DEVELOPMENT APPLICATION ASSESSMENT REPORT

Application Number:	DA2025/0198
----------------------------	-------------

Responsible Officer:	Brittany Harrison
Land to be developed (Address):	Lot 43 DP 13325, 23 Park Avenue AVALON BEACH NSW 2107
Proposed Development:	Alterations and additions to a dwelling house
Zoning:	C4 Environmental Living
Development Permissible:	Yes
Existing Use Rights:	No
Consent Authority:	Northern Beaches Council
Land and Environment Court Action:	No
Applicant:	Helen Mary Owens

Figure 1: Red shading indicates existing deck to be demolished in similar location to the new roof terrace.

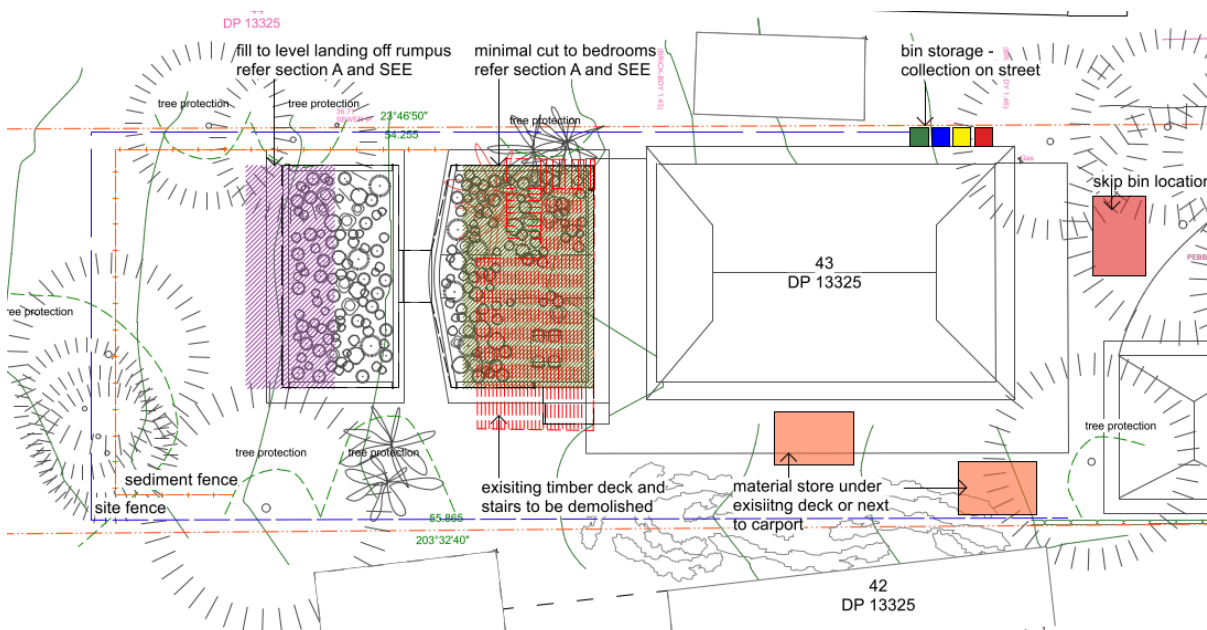
The existing dwelling includes an elevated deck from the front of the dwelling, which wraps around the eastern side toward the rear, opening up to an entertaining/alfresco area. The proposal seeks to demolish part of the rear entertaining deck to accommodate the new extension below, which will feature a new entertaining area atop the lower floor extension (refer to Figure 1 below). The new roof top terrace is less than 9.0m from the adjoining property boundary.

The new elevated terrace will be located similarly to that of the existing decking particularly to the eastern side. Screen vegetation and trees are located along the boundary providing a landscaped

buffer between the deck and the adjoining swimming pool to the east. It is considered that the visual privacy will remain similar to existing (refer to Image 1 and 2 below).

To enhance privacy when the roof terrace is in use, a condition is recommended for the balustrades on the eastern and western edges to be of opaque glass or timber battens. This will allow for a disruption in view when entertaining/dining down toward the adjoining rear yards or alternatively up from the adjoining rear yards to the roof terrace.
